Rezoning Transportation Analysis

Petition Number: Insert Zoning Petition #2021-239

Date	Description
02-18-2022	First Review (AO)
03-23-2022	Second Review (AO)

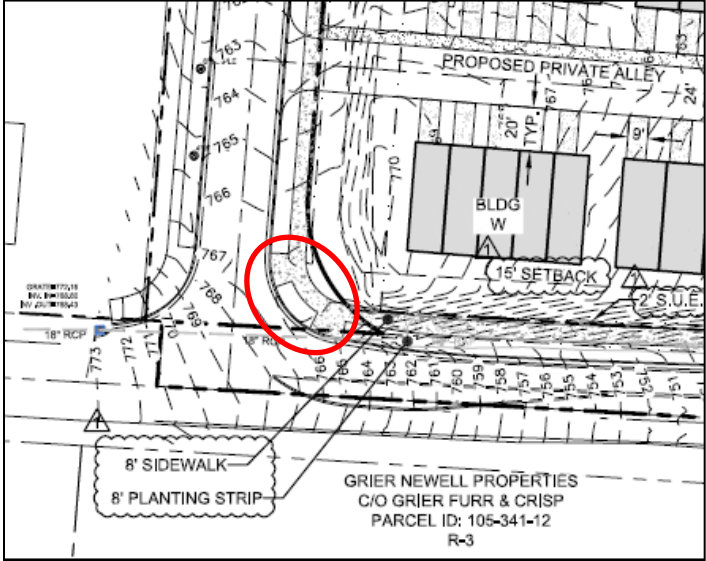
4. **Rescinded:** ~~Site plan and conditional note(s) revisions are needed to commit to construct bicycle facilities by installing a 12' multi-use path along E WT Harris Blvd outside of the control of access and within a public access easement to meet the City Charlotte BIKE Policy.~~
